Opinion on Payment for Provision of Flexible Ramping

Market Surveillance Committee of the California ISO

August 11, 2011

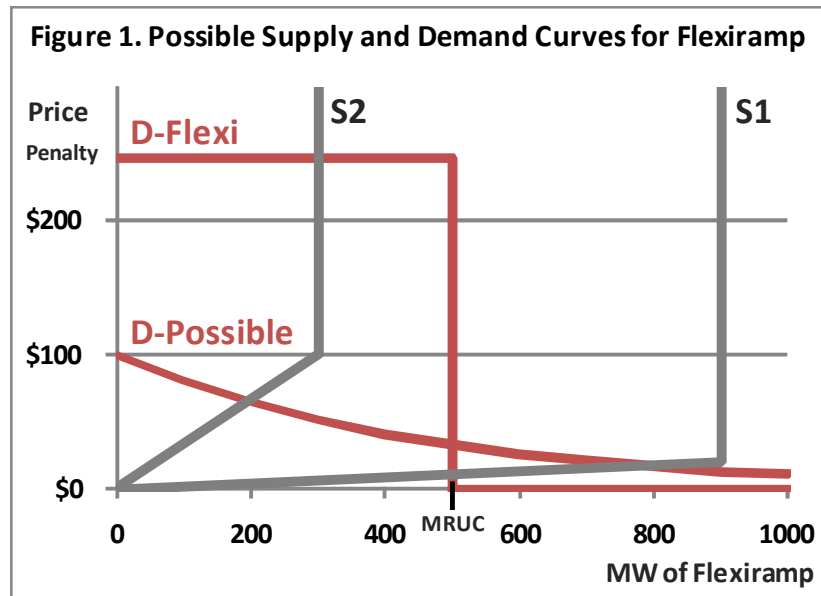
The RTPD’s process for acquiring flexiramp can be viewed as an interplay of a demand curve for flexiramp with supply. In particular, the MRUC requirement in combination with the penalty price on the flexiramp constraint defines the ISO’s demand curve (shown as D-Flexi in Figure 1) for the flexiramp product.

The higher, step-function demand curve, labeled D-Flexi is the demand curve determined by the flexiramp proposal, although MRUC will vary from hour to hour. The lower, smooth demand curve, labeled D-Possible, is one possibility for what an optimal demand curve might look like. (It is possible, of course, that the optimal curve might be higher than D-Flexi for some values of flexiramp to the left of 500 MW; we do not mean to prejudge the marginal value of flexiramp.) In one respect, D-Possible is more reflective of the value of flexiramp than D-Flexi because it is smooth. It is unrealistic to think that MRUC could be worth \$247/MWh (its penalty price) when 499 MW is available and \$0/MWh when 501 MW is available. Such an on-off demand curves makes sense when complying with a black-and-white regulatory requirement, such as NERC’s requirement for operating reserves, but they make little sense (except as operational compromises) when they are meant to reflect the value of a physical hedge against random contingencies. The penalty level of the D-Flexi demand curve is also unlikely to reflect the economic value of flexiramp since it was determined with little regard for the value of flexiramp.

Fortunately, based on reports of the ISO’s market simulations of flexiramp, the supply curve for flexiramp seems to be frequently most similar to S1. In other words, flexiramp is anticipated to be usually very inexpensive. In this case the D-Flexi curve will demand too little, but will pay a lower price, often zero, for a fairly generous supply of flexiramp. However if the system runs into conditions under which flexiramp is not cheap, perhaps as shown by supply curve S2, then using the wrong demand curve will likely cause significant over procurement at an uneconomic cost. Since the ISO’s reported simulations indicate that a generous supply of flexiramp is currently available, we do not recommend a change in the current design. However, for the ISO’s Renewable Integration Market & Product Review, Phase 2 (“Renewable Integration Review”), we suggest that the demand side of the market be seriously considered in a manner consistent with scarcity pricing for other market products.
